REVIEWED ONLY AS TO GENERAL COMPLIANCE WITH THE INTENT OF THE GRADING AND SERVICING DRAWINGS. THE ENGINEER DOES NOT WARRANT THAT THE INFORMATION CONTAINED ON THIS PLAN IS EITHER ACCURATE OR CORRECT. SOLE RESPONSIBILITY FOR CORRECT DESIGN, DETAILS AND DIMENSIONS WILL REMAIN WITH THE PARTY SUBMITTING THE DRAWING

ROUNDEL HOMES INC. (PH-2)

LOT No. 52

PRAIRIE ROSE DRIVE

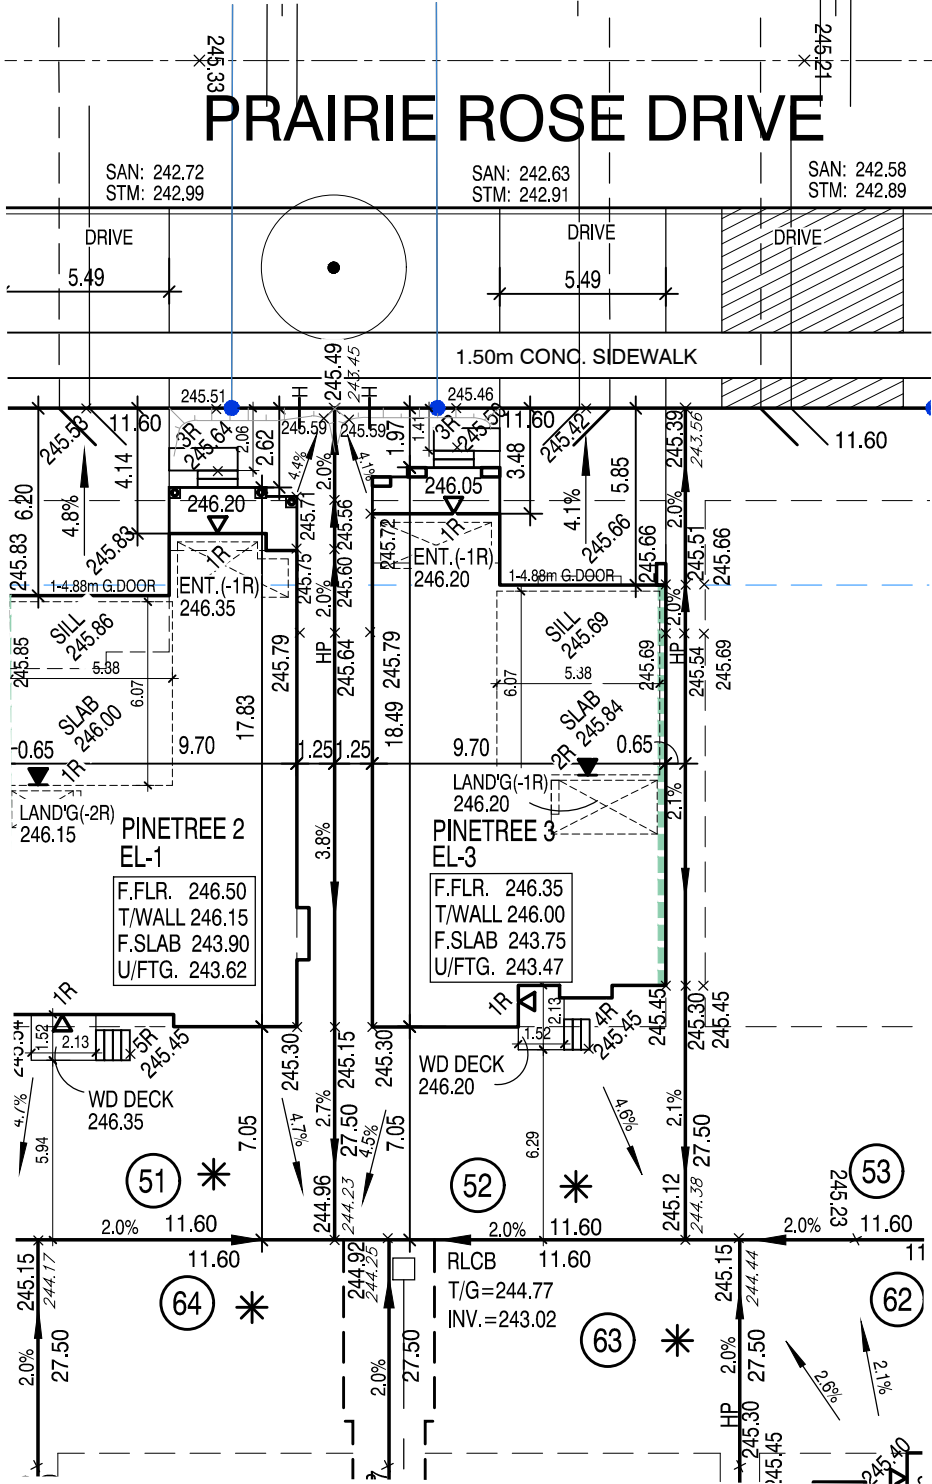
No unprotected openings permitted within 1.2 metres of the lot line as per 9.10.14 of the Ontario Building Code.

45 MINUTE RATED WALL WITH SIDE YARD < 1.2m
